Access Compliance Report

Public Rights-of-Way

(Island Curb Cuts)

| Intersection ID: 15542 | Main Street: CLANTON_RD | Cross Street: N_CLANTON_TO_S_I-77_RA_NB | Location: S |

| ADA ID: 7D48D900607B | Curb Cut Type: IslandRefuge3 | Initial Pass/Fail: Fail | Overall Compliance: No |

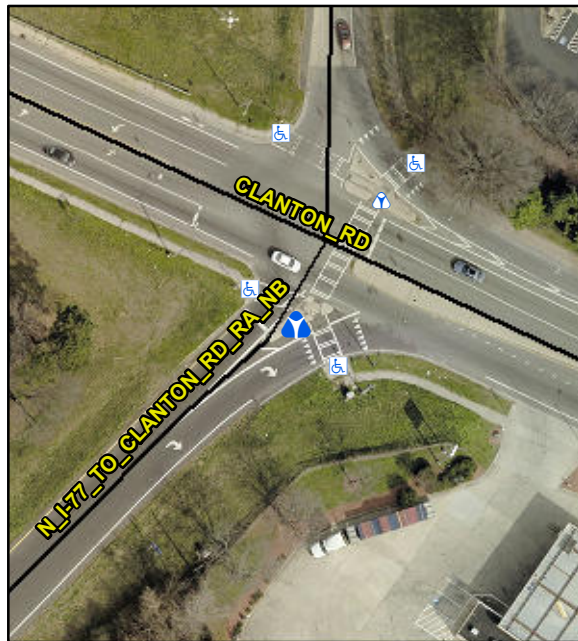
| Compliance | Description | Data | Compliance | Description | Data |
|------------|----------------------|-------|------------|-----------------------------|------|
| No | Refuge 1 Width (In) | 59.0 | N/A | Gutter 1 Lip Ht (In) | N/A |
| No | Refuge 2 Width (In) | 59.0 | N/A | Gutter 2 Lip Ht (In) | N/A |
| No | Refuge 3 Width (in) | 58.0 | N/A | Gutter 3 Lip Ht (in) | N/A |

Remove & Replace Entire Refuge.
